LRB-2020-13 – 19/01781/FLL - Erection of a dwellinghouse, land 40 metres north west of Carraig Mhor, Sauchie Road, Crieff

**PAPERS SUBMITTED
BY THE
APPLICANT**

PROPOSED Single House Development
Site at Sauchie Road, Crieff

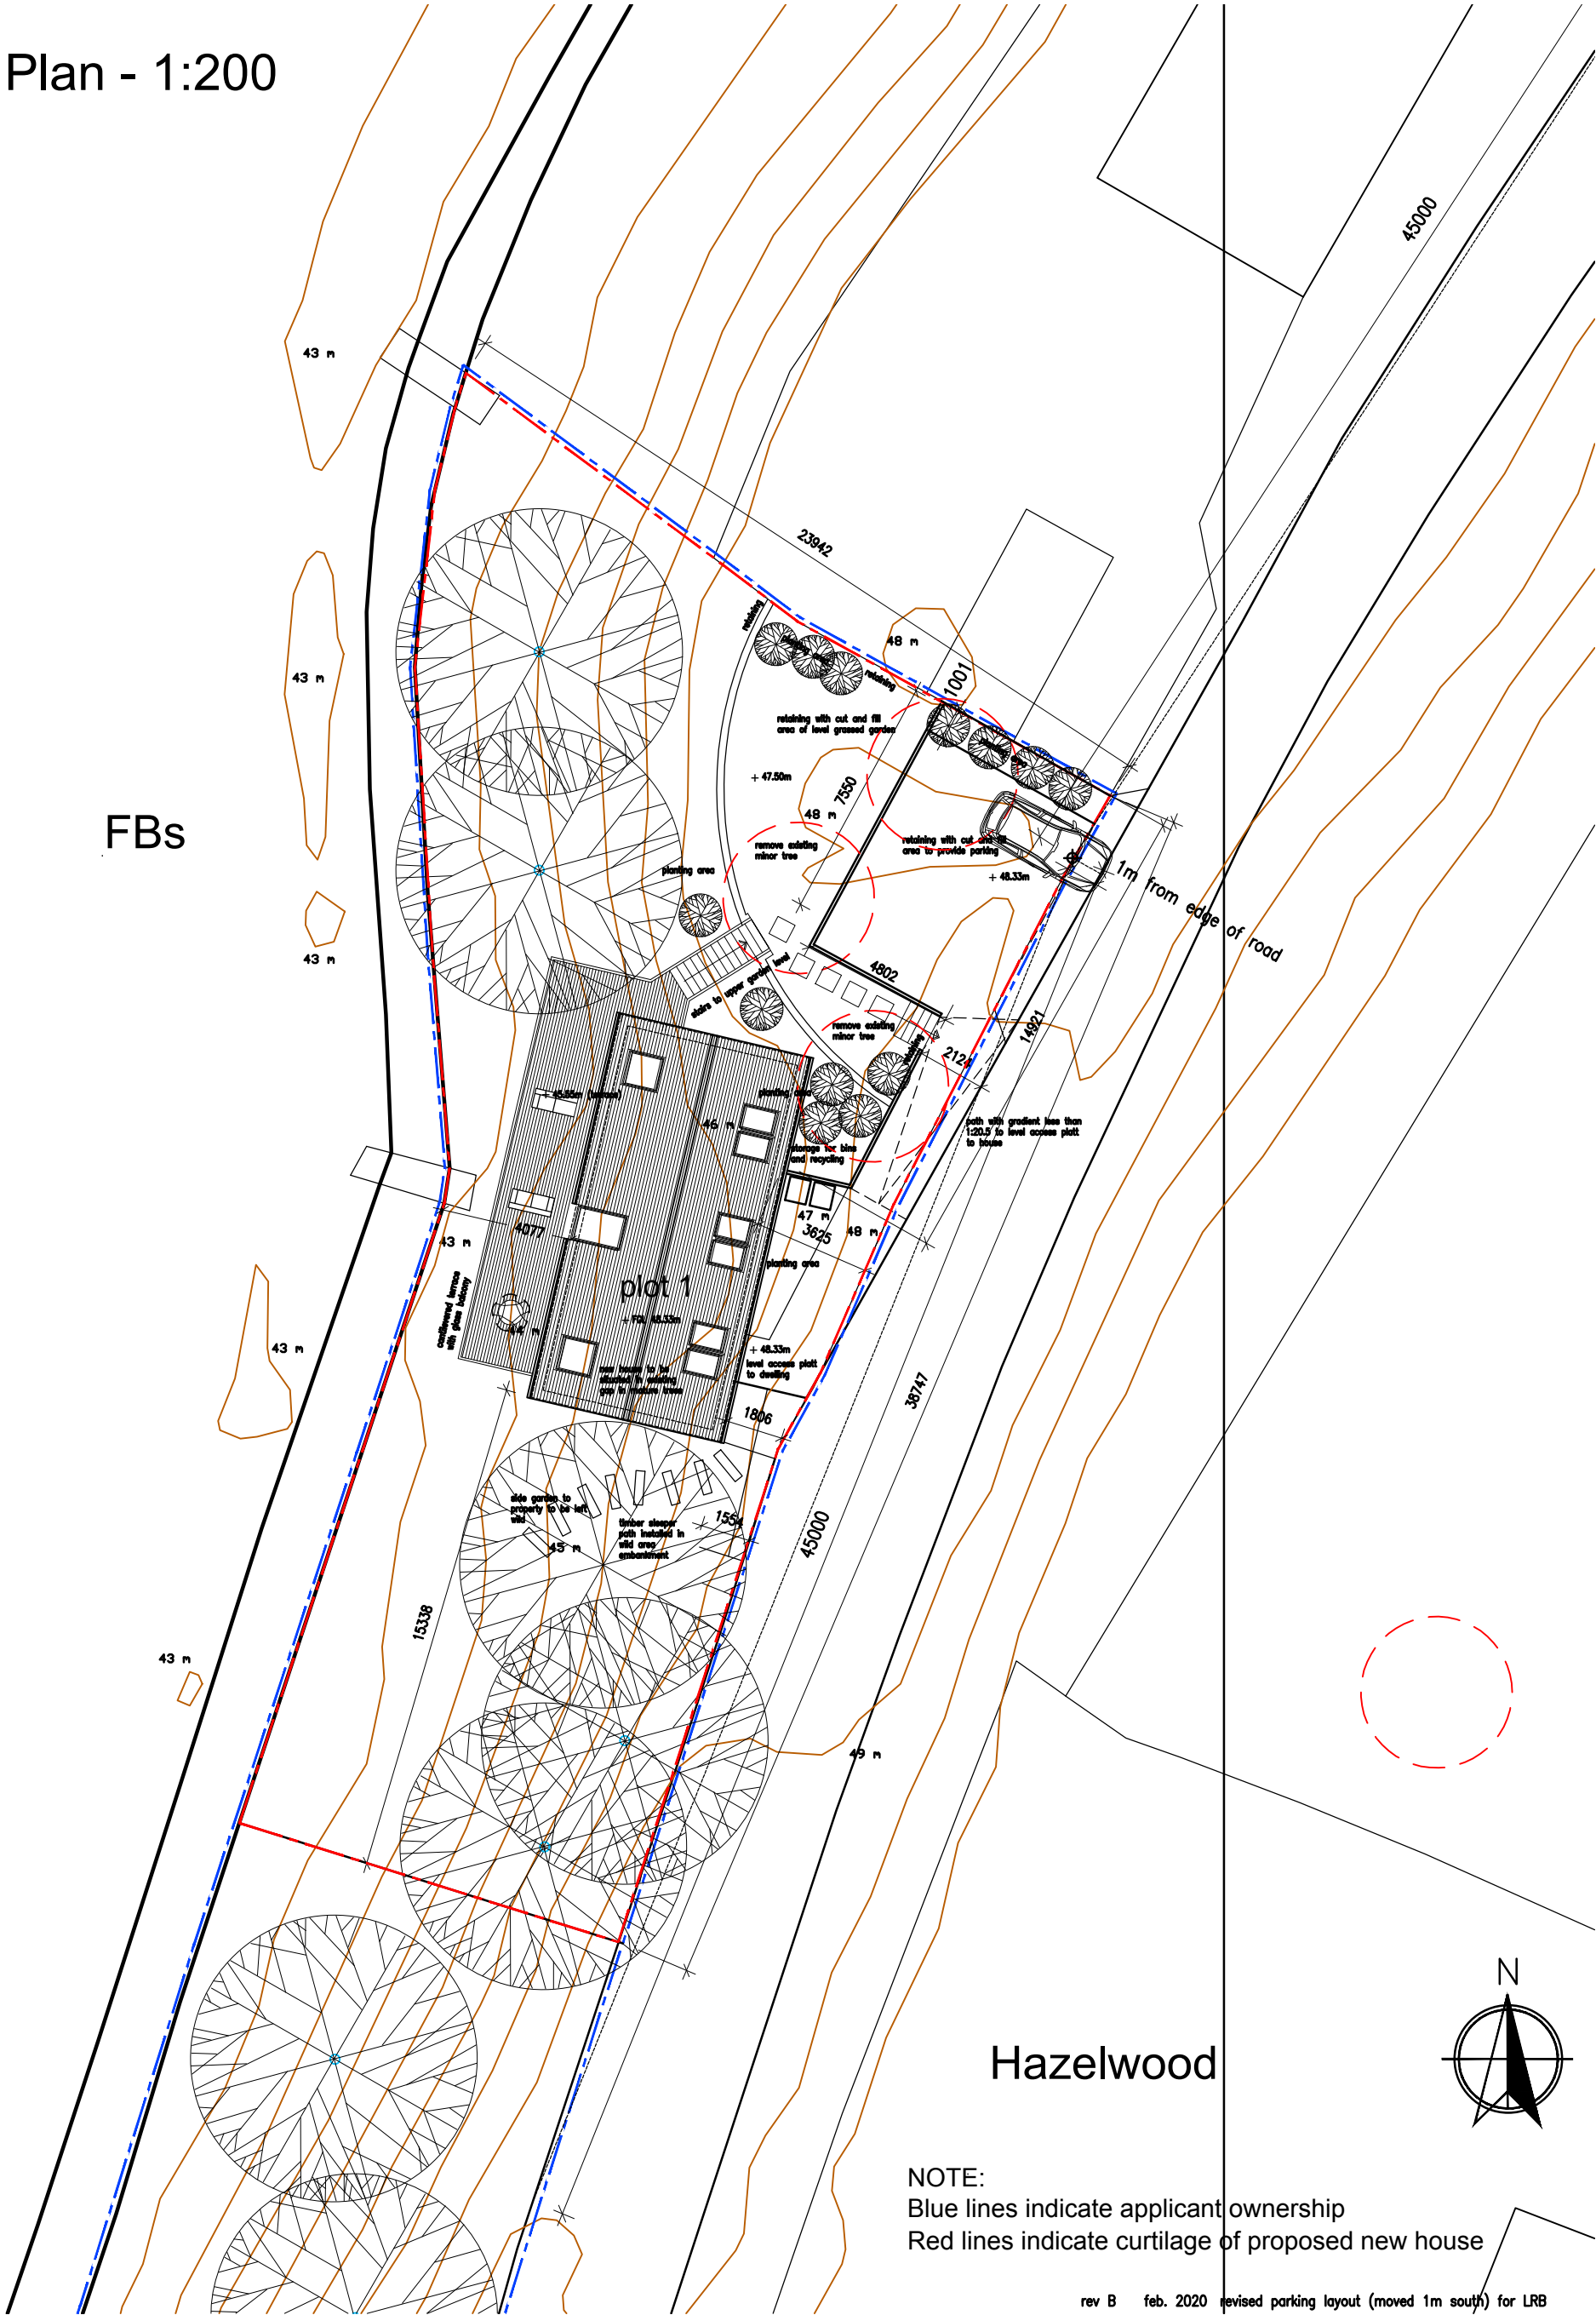
6. The proposal is contrary to Policy 60B of the Perth and Kinross Local Development Plan 2019 as the parking area as shown on the proposed plan does not allow for vehicles to turn and access the carriageway in a forward gear, and the location of the parking area is immediately adjacent to an existing neighbouring fence which will impact considerably on forward visibility.

- It is noted that the planning officer who was appointed to this case was off ill during the initial planning period and no request was made of the applicant in this regard and it is our assertion that this contributed to not having the opportunity to address this during the application itself. We attach a revised site layout plan, which shows the slightly amended parking arrangement and achievable visibility splays, which is in compliance, we believe. The splay requirement is actually easy to achieve and surpass due to the bends in the road at our proposed site. Maximum calculated visibility splays north are around 90m and 80m south.

- It is noted that the visibility splay requirement and the requirement for accessing the carriageway in a forward gear is not clearly referenced to in the local planning policy document, Nor is any guidance to be found in the supplementary planning guidance documents or anywhere on Perth and Kinross' website (in fact a phone call to the person answering calls for this dept. couldn't find it either!).

Proposed Site Plan

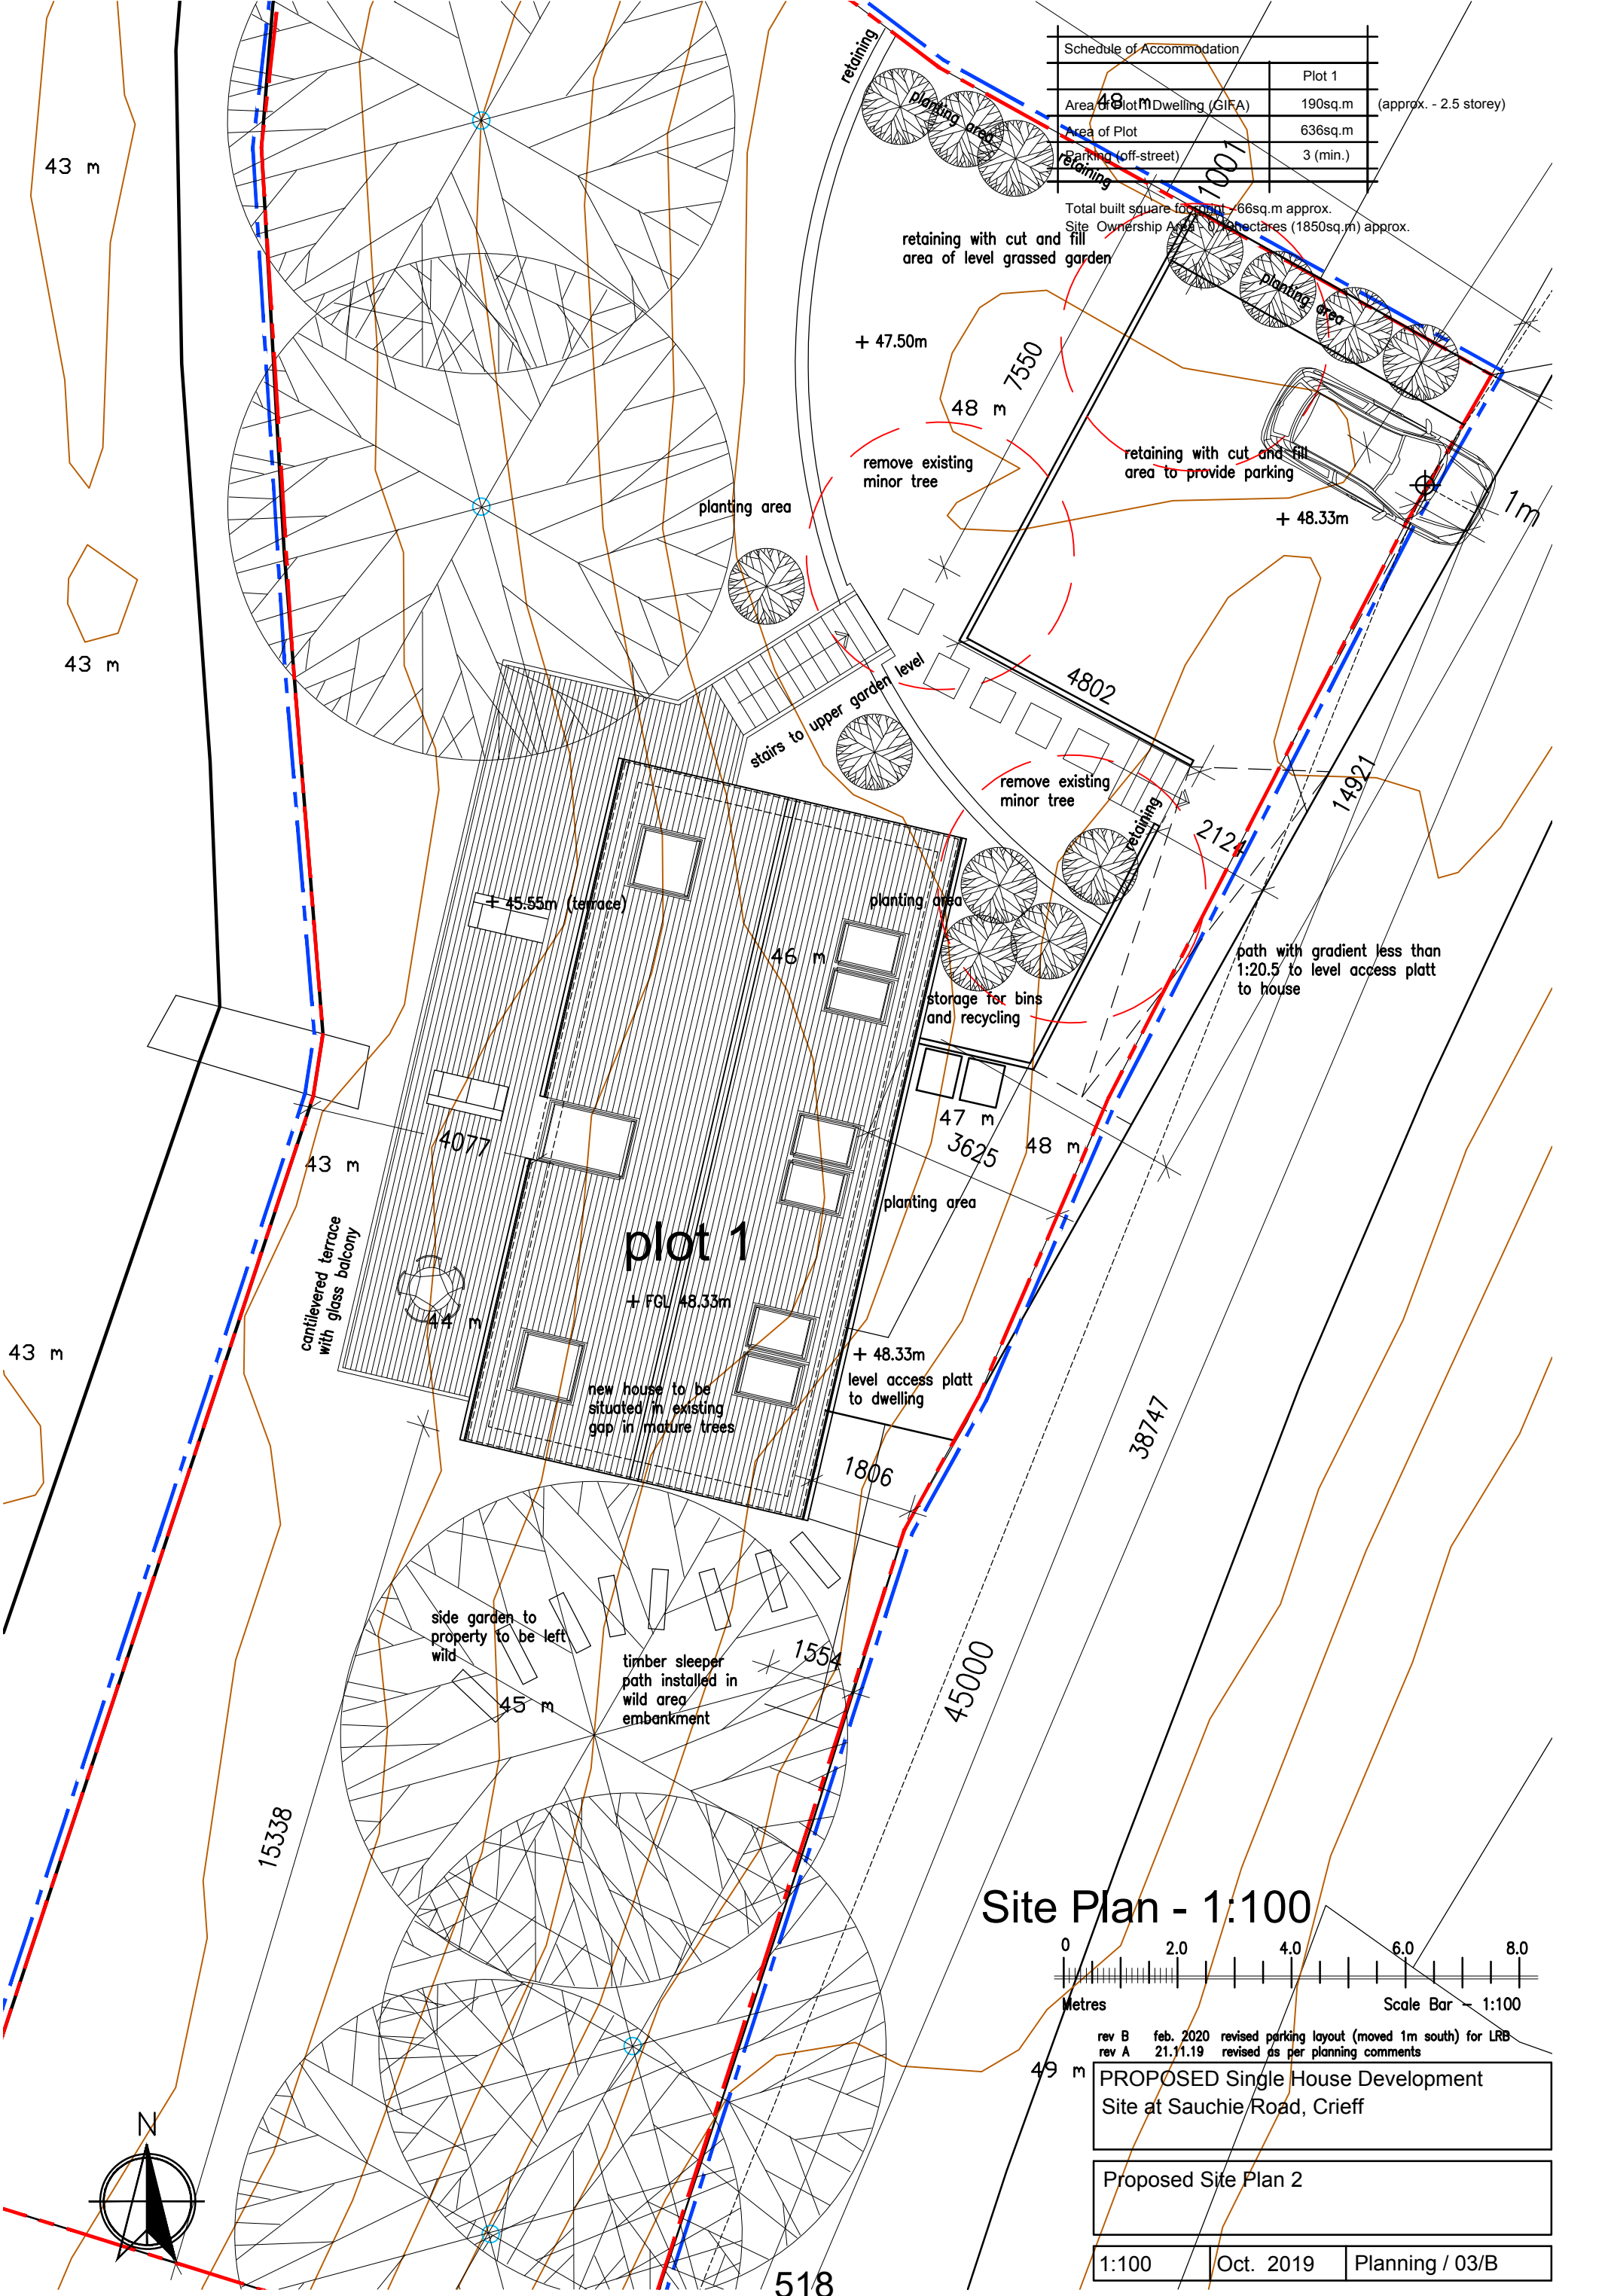
- 6 The proposal is contrary to Policy 60B of the Perth and Kinross Local Development Plan 2019 as the parking area as shown on the proposed plan does not allow for vehicles to turn and access the carriageway in a forward gear, and the location of the parking area is immediately adjacent to an existing neighbouring fence which will impact considerably on forward visibility.

- It is further argued that the requirement for all required numbers of parking vehicles entering and leaving the site in a forward gear has not been achieved by any of the existing single house plots on Sauchie Road (what tends to be the case is that residents reverse into their own drive – which would ultimately be the case on our development) – we would therefore argue that it is an unfair comment to make on our proposals only. We would ask whether this requirement is ultimately practicable in the circumstances and whether it should be considered as a material requirement for approval of the development.

rev B feb. 2020 revised parking layout (moved 1m south) for LRB
rev A 21.11.19 revised as per planning comments

Figure 3. Annotated site topographical plan showing locations of trees with bat roost potential.

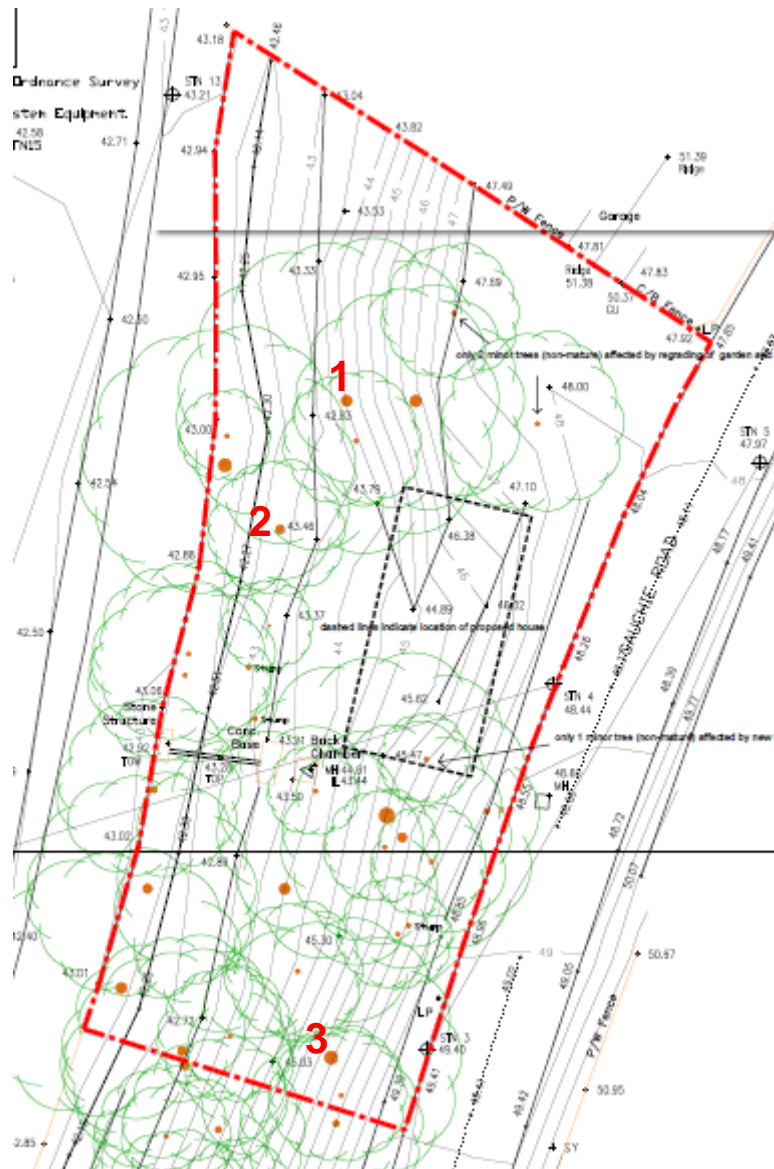
5. The proposal is contrary to Policy 41 of the Perth and Kinross Local Development Plan 2019 as no information has been provided to assess the impact of the proposed development on protected species.

Tree cover on the site is likely to provide shelter for foraging and commuting bats.

Trees on site and the continuation of the woodland cover occupying the sloping ground of the site is likely to provide sheltered foraging areas and commuting routes for foraging bats in the wider area. It is assumed that the western edge of the site is most suitable for foraging and commuting bats as this is both sheltered at the base of the slope and shaded from the streetlights of Sauchie Road.
